**MONTGOMERY COUNTY HISTORIC PRESERVATION COMMISSION**  
**STAFF REPORT**

<b>Address:</b>	10 Laurel Parkway, Chevy Chase	<b>Meeting Date:</b>	5/27/2020
<b>Resource:</b>	Non-Contributing Resource <b>Chevy Chase Village Historic District</b>	<b>Report Date:</b>	5/20/2020
<b>Applicant:</b>	Allison Marvis (V.W. Fowles, Architect, Martin Locraft, Agent)	<b>Public Notice:</b>	5/13/2020
		<b>Tax Credit:</b>	N/A
<b>Review:</b>	HAWP	<b>Staff:</b>	Michael Kyne
<b>Case Number:</b>	35/13-20Q		
<b>PROPOSAL:</b>	Building addition and other alterations

*Fig. 1: Subject property, as marked by yellow star.*

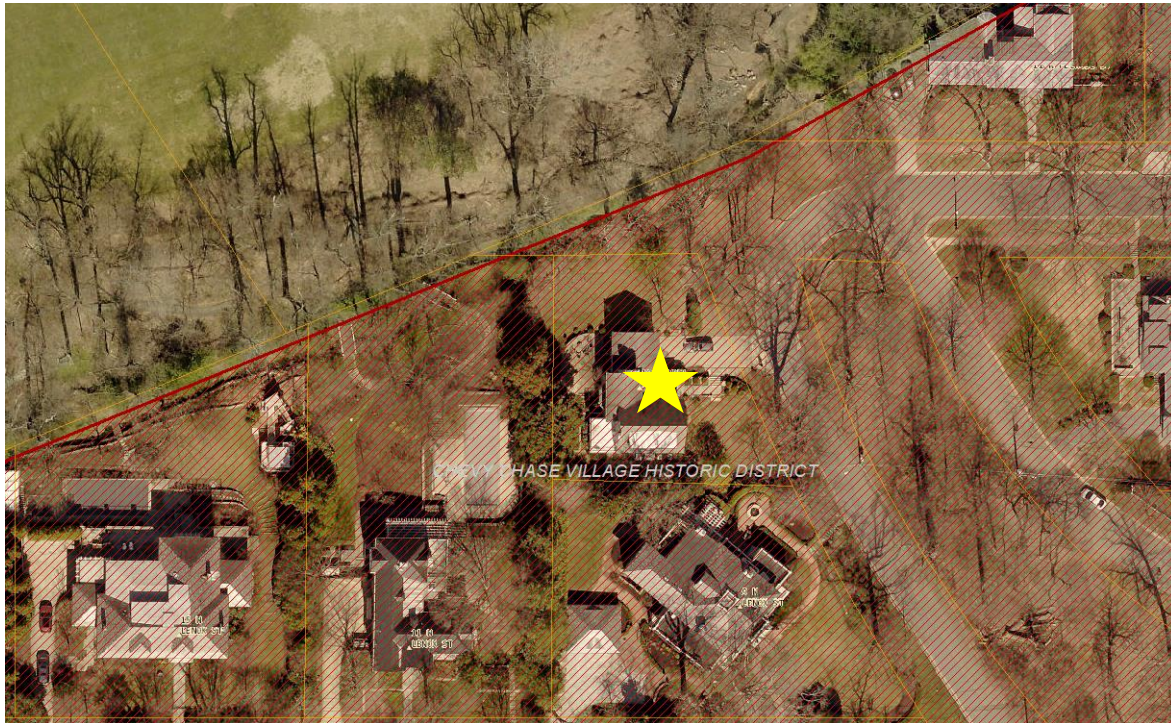
The subject property is a c. 1957 modern split-level Non-Contributing Resource within the Chevy Chase Village Historic District. The property is at the edge of the historic district, with one adjacent Contributing Resource (9 West Lenox Street to the south), one adjacent Outstanding Resource (11 West Lenox Street to the west), and two confronting Contributing Resources (8 West Melrose Street to the east and 11 West Melrose Street to the northeast).
